IRAQI CIVIL DEFENSE
HEADQUARTERS
BAGHDAD, IRAQ

SIGIR PA-06-090
APRIL 26, 2007

SUBJECT: Report on Iraqi Civil Defense Headquarters, Baghdad, Iraq (Report Number
SIGIR PA-06-090)

Figure 2. Contractor's as-built drawing for building A bathroom (enlargement)

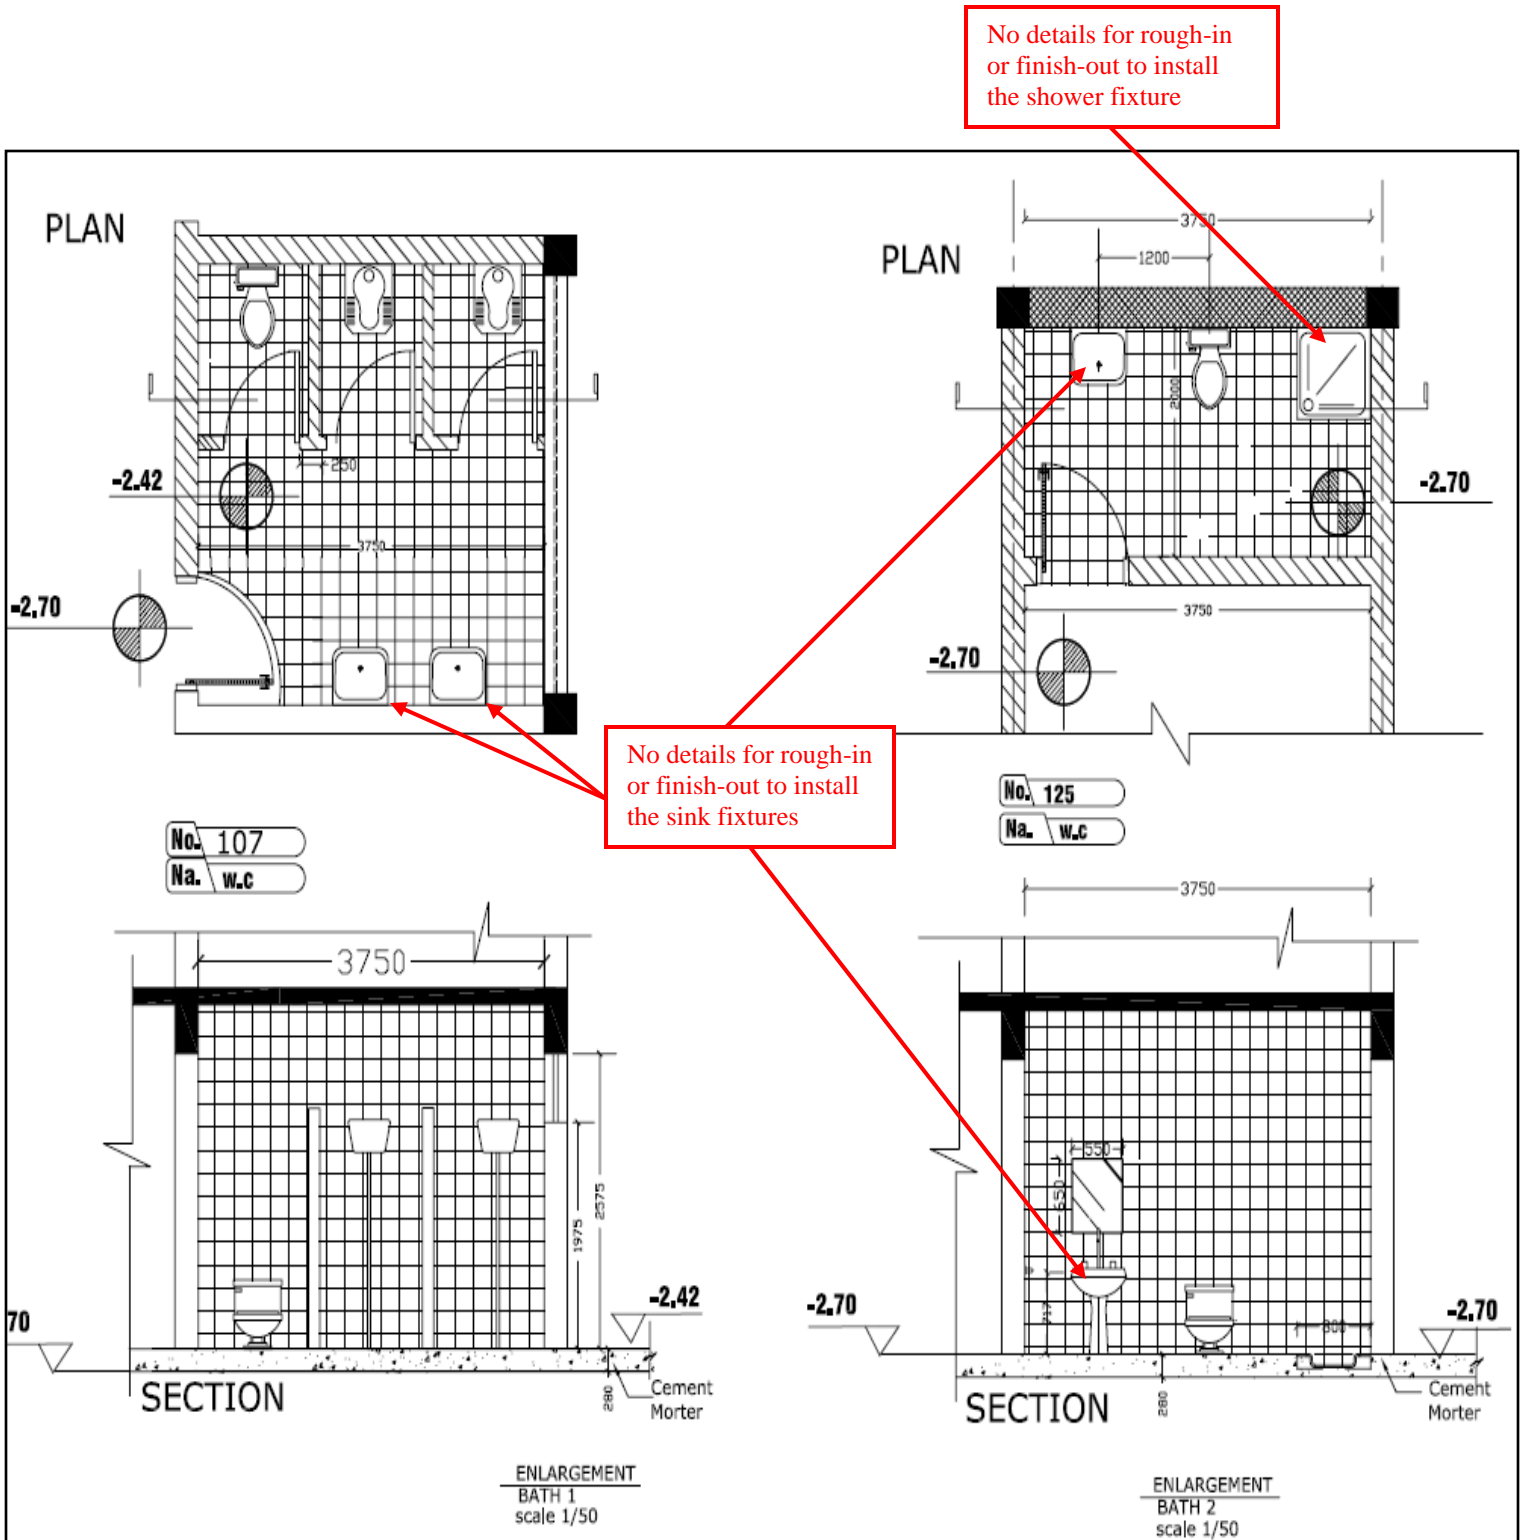
We reviewed the design drawing submittal marked as the 100% final drawing package and found them inadequate due to the absence of quality, detailed design construction

drawings. It is customary to show construction detail for individual items as well as Typical Details for items or components used at multiple locations. All construction detail shows the material, method, and critical dimensions to perform the task for the benefit of the installer. The contractor's drawings lacked significant and basic design details, such as the rough-in and finish-out for the installation of plumbing fixtures (a riser diagram for both fresh water and soil piping) and the need for an adequate number of cleanouts and traps. Further, there was a significant omission with regards to the location and correct type of building expansion joints.

Detailed design drawings for the rough-in and finish-out of the plumbing fixtures were not provided by the contractor. Instead the drawings were generic and did not specify the distance the hot and cold water lines should extend beyond the wall (i.e. rough-in) for the plumber to connect to the shower faucet and head (Figure 2). In addition, the drawings do not provide an enlargement of one toilet or shower as an example to provide specific installation details, such as the type of plumbing fixtures to use (i.e. finish-out). Without detailed design drawings, the subcontractor does not have adequate guidance to properly install the water lines and plumbing fixtures.

Based upon our review of the GRD design submittal documentation, it appears inadequate to renovate and construct the ICD HQ. Without the required design submittal packages, we could not determine if the requisite information was included. In addition, the government representative who apparently had access to the design submittal packages, rejected the 30% and 90% design drawings because they were not complete and lacked important information.

Figure 7. Contractor as-built drawing for ICD HQ building A bathroom

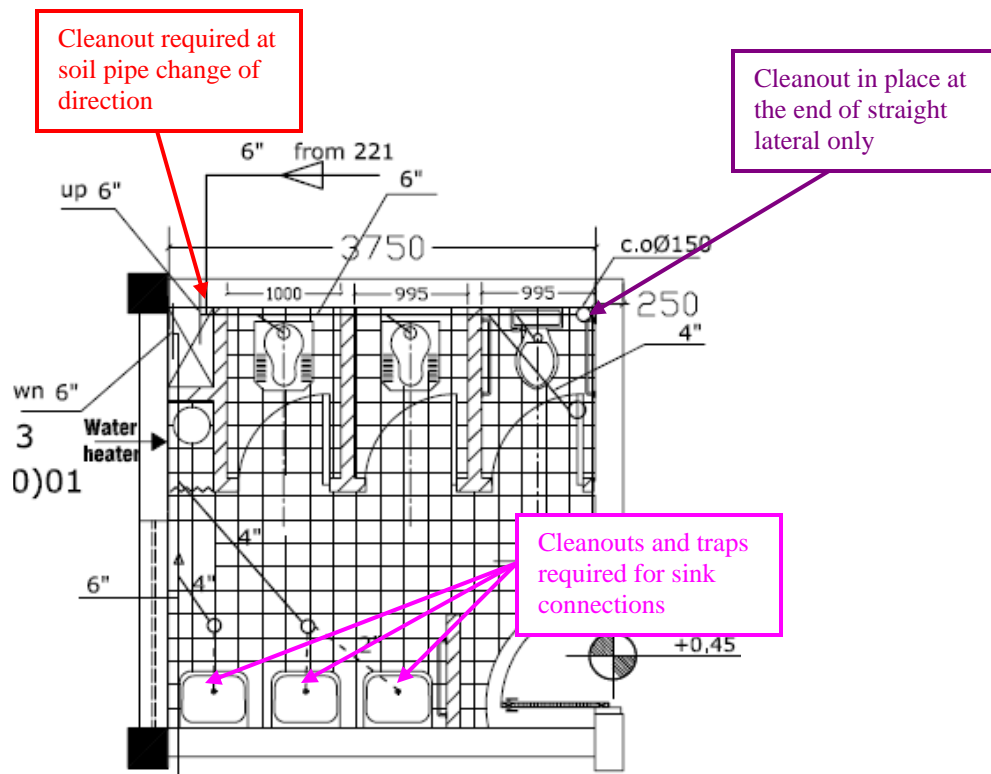
The contractor did not provide the required cleanouts for soil pipe at multiple locations of the ICD HQ buildings. For example, each toilet and shower required the use of a cleanout since the drains connected to the sewer lines at a change in direction. In addition, there are no traps installed for the shower soil pipes. Without the required

cleanouts or traps for the toilets and when soil pipes change directions, solid waste is very likely to collect and ultimately clog the pipes, resulting in backup of the waste water and an unpleasant odor. However, GRD representatives stated that cleanouts are not required for each sink, toilet, and shower because backups can be fixed with the “use of snakes.” While the use of snakes may be effective in clearing out some backups, it will have significant limitations. For example, a snake will only reach so far into a pipe and will often only push the substance clogging the line further down the pipe. At some point, the snake will not be able to reach far enough to continue clearing the pipe (Site Photo 9). Further, GRD representatives previously stated at another project site that Iraqis do not use snakes to clear drains and/or pipes.

The as-built drawings for the ICD HQ bathrooms indicate cleanouts were only used at the far end of a straight run of soil pipe, not for every toilet trap and change of direction (Figure 7). Since the 30% and 60% design drawings were unavailable for our review, we cannot determine whether the government engineers reviewing the bathroom design drawings failed to detect and identify the lack of sufficient number of cleanouts and traps at the correct locations. However, the government design reviews do not mention the absence of cleanouts and traps at the correct locations as a deficiency.

Figure 13. Contractor as-built drawing of the third floor light fixtures

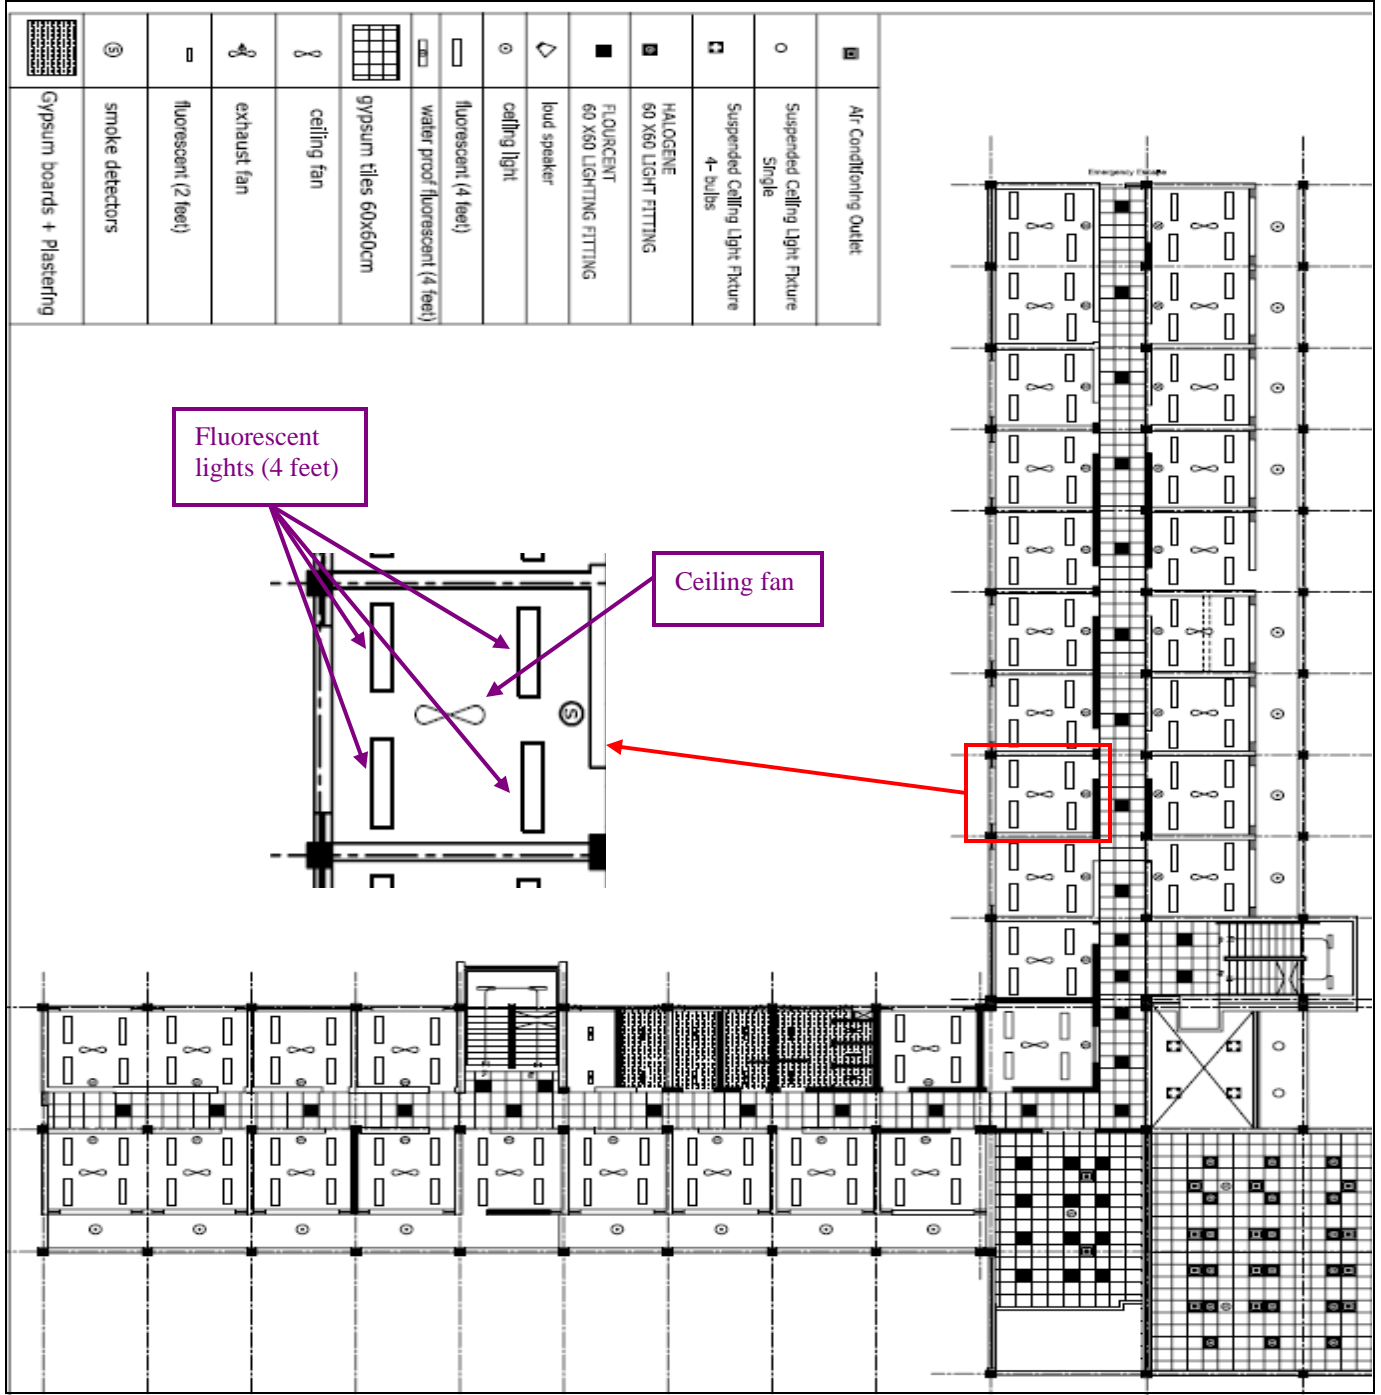
Since the ICD HQ buildings were stripped clean of lighting fixtures during the 2003 looting, the contractor needed to install lighting and ceiling fans in each room, which was reflected in Parsons’ as-built drawings. The typical room consisted of four double fluorescent lights (each four feet long) and one ceiling fan (Figure 13).

The as-built drawings do not include any electrical drawings; specifically, there are no electrical line drawings and branch circuit distribution plans. Without this information, the ICD HQ personnel will not know the size of the circuit load and breakers, type, quality, and gauge of wire, as well as load factor for distribution design. This information is critical for proper maintenance and repair of the electrical system.

Figure 16. Contractor’s as-built drawing for expansion joint for ceiling and floor slab

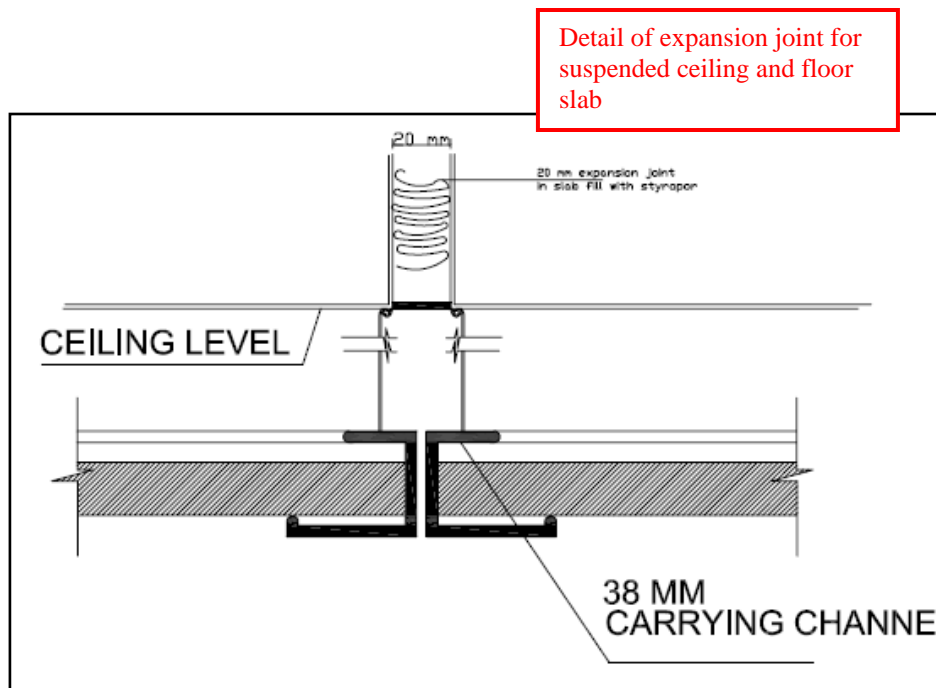
“complete” as-built drawings, no expansion joints were used on the floor, wall, or roof of the ICD HQ building. However, both GRD and ICD HQ personnel stated that at least one expansion joint was installed on the exterior wall of the ICD HQ building (Site Photo 58). The location of this expansion joint is questionable because it does not appear to be in the correct spot (Figure 18). Further, the installation of the expansion joint does not appear to be done correctly (Site Photo 59). The intent of an expansion joint is to allow a building to withstand thermal expansion and contraction and foundation movements; however, the fact that the subcontractor put plaster on top of the expansion joint negates its effectiveness.

We found no evidence of the installation of any type of expansion joint system at any location in this building.

Figure 19. Sliding door fabrication detail (from as-built drawings)

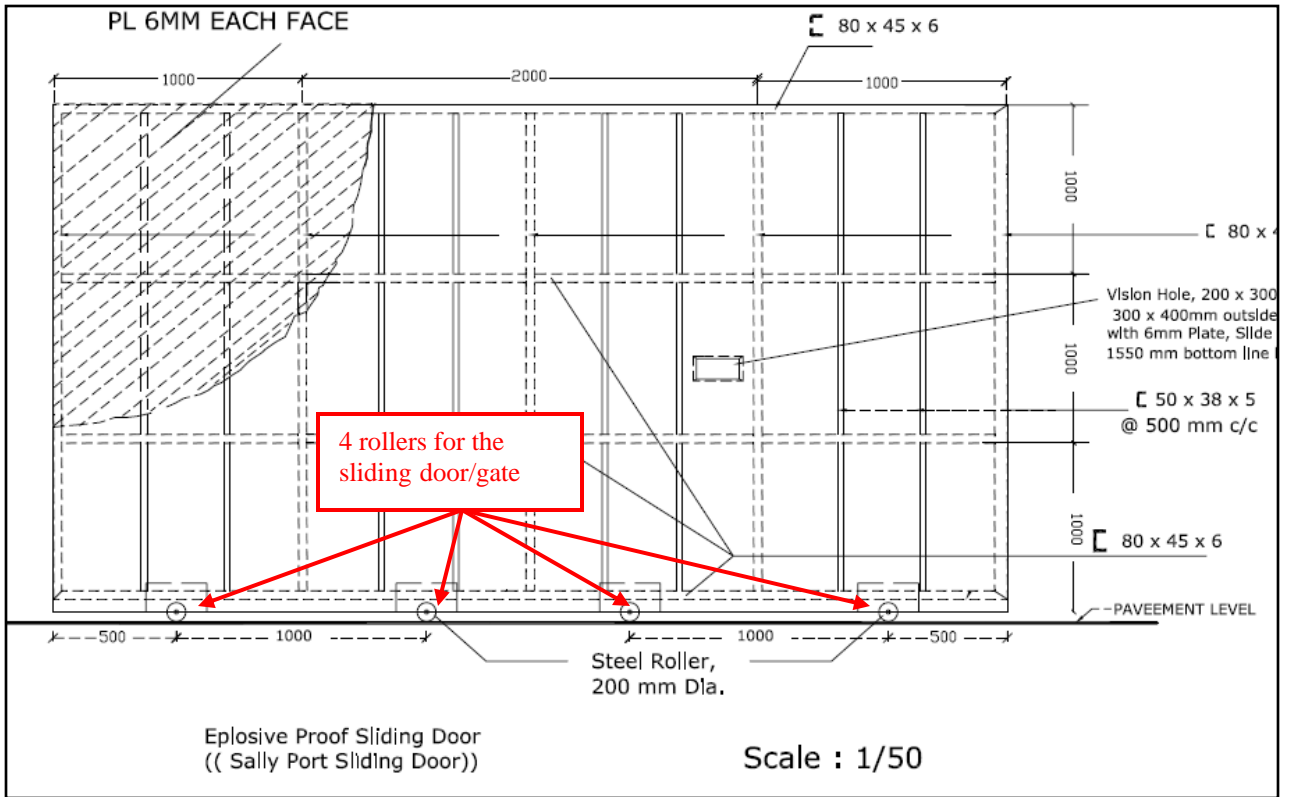
The as-built drawings for the Sally Port sliding gate indicate that each gate has four rollers/wheels and one vision hole (Figure 19). However, during our site visits, we identified that each gate had only two rollers/wheels and at least one gate had no vision hole (Site Photo 60). The lack of two additional rollers means the weight of the anti-explosive gate is distributed over two fewer wheels, resulting in additional stress on the two rollers. The vision hole is critical to enable the sliding gate guard to identify those attempting to enter the ICD HQ compound. Without a vision hole, the guard will have to partially open the sliding door in order to identify anyone approaching; this significantly increases the danger to the guard and the compound.

Figure 21. Contractor's as-built drawing (directional) for the sewer lines at the ICD HQ compound

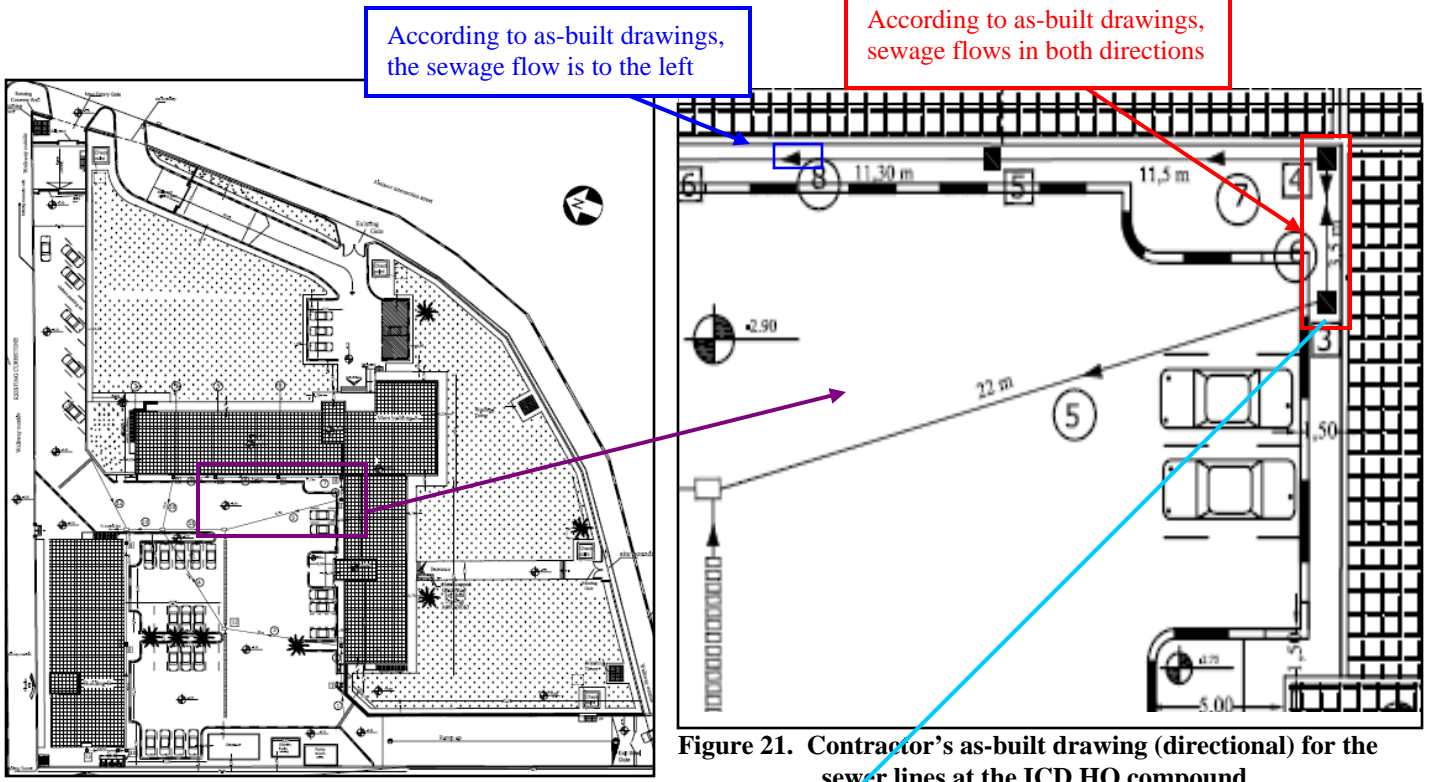
The sewage line site plan as-built drawings for the ICD HQ main building does not provide a correct sewage flow diagram (Figure 20). For example, in one instance sewage appears to flow in opposite directions (Figure 21), which is not possible considering the sewage lines run directionally by gravity. We lifted the manhole cover (Site Photos 61 and 62) and determined that the sewage actually flowed from Box 4 to Box 3. In another instance, the direction of the sewage flow is not correct. Figure 21 shows sewage directional flow running from Box 4 to the left toward Box 5; however, when we lifted the manhole cover, we determined the flow of the sewage line was running from Box 5 to the right to Box 4 and then downward to Box 3 (Figure 22 shows the correct directional flow of sewage lines).
